Access Compliance Report

Public Rights-of-Way

(Curb Ramps)

Intersection ID: 2855	Main Street: SWANSTON_DR	Cross Street: TORPHIN_CT	Location: NE
ADA ID: C0333BC2186A	Ramp Type: PerpDiag	Initial Pass/Fail: Fail	Overall Compliance: No
Severity Score: 12.5			
Codes/Mitigation Info/Possible Solution		Field Measurements/Component Compliance

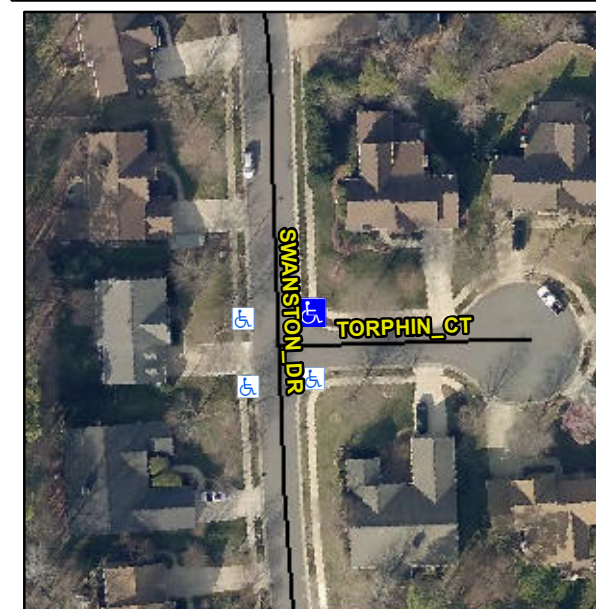
Not Found, R304.2.2

Compliance	Description	Data	Compliance	Description	Data
N/A	Ramp Length (in)	48.0	No	Ramp Slope (%)	9.9
Yes	Ramp Width (in)	60.0	Yes	Ramp XSlope (%)	0.1
N/A	Flare Type LT	N/A	N/A	Flare Type RT	N/A
N/A	Flare Slope LT (%)	N/A	N/A	Flare Slope RT (%)	N/A
N/A	Flare Traversable LT?	N/A	N/A	Flare Traversable RT?	N/A
N/A	Landing Length (in)	N/A	N/A	DWS Provided?	N/A
N/A	Landing Width (in)	N/A	N/A	DWS Contrast?	N/A
N/A	Landing Slope (%)	N/A	N/A	DWS Length (in)	N/A
N/A	Landing X Slope (%)	N/A	N/A	DWS Full Width?	N/A
N/A	Landing Curb? (Y/N)	N/A	N/A	DWS Offset (in)	N/A
N/A	Shared Landing?	N/A			
N/A	Gutter Ponding?	N/A	N/A	Gutter Slope (%)	N/A
N/A	Gutter Lip Ht (in)	N/A	N/A	Gutter X Slope (%)	N/A
N/A	Painted X Walk1?	No	N/A	Painted X Walk2?	No
	X Walk 1 Direction	To W		X Walk 2 Direction	To S
N/A	X Walk 1 Width (in)	N/A	N/A	X Walk 2 Width (in)	N/A
	X Walk 1 Slope (%)	4.6		X Walk 2 Slope (%)	1.9
	X Walk 1 X Slope (%)	1.6		X Walk 2 X Slope (%)	3.4

Remove & Replace Curb Ramp With Two New Directional Ramps or Equivalent.
